LK35, LK35B and LK35L Models

Project Name: Webster University-**ISB**

Copies	No.	Description
1 PDF	224216P02	(Submittal No.'s)
		(Cannon #22 4216.16-001) - (Paric #15051-) - (WES #607)
		➤ Commercial Sinks
		• Clinical Service Sink CSS-1
		• Scrub Sink SS-1
		• Sink SK-1
		• Garbage Disposer GD-1
		• Sink SK-2
		• Sink SK-3
		• Mop Sink MS-1
		• Kitchen Sinks KS-1, KS-2, KS-3

SPEC SECTION: 22 4216.16
Commercial Sinks

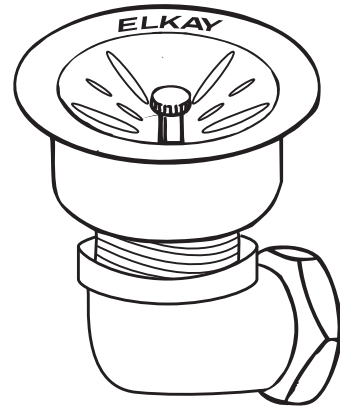
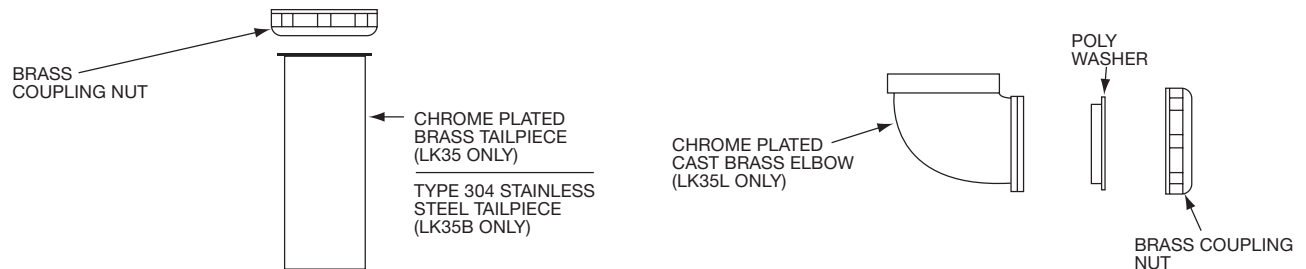
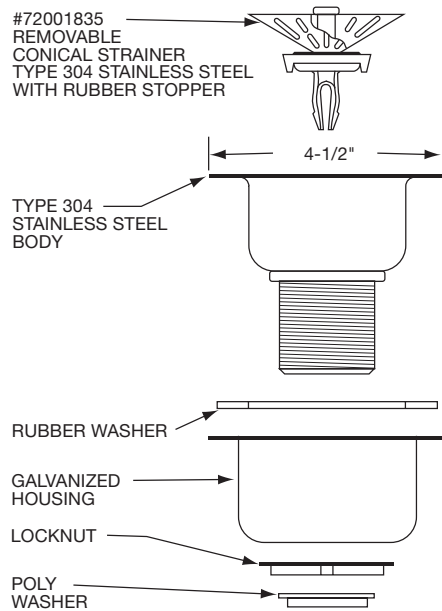
1. Provide under counter waste and supply protective piping covers as required.
Verify requirements with the architectural drawings.
2. Escutcheons are specified to be cast brass. Refer to specification section 220518.
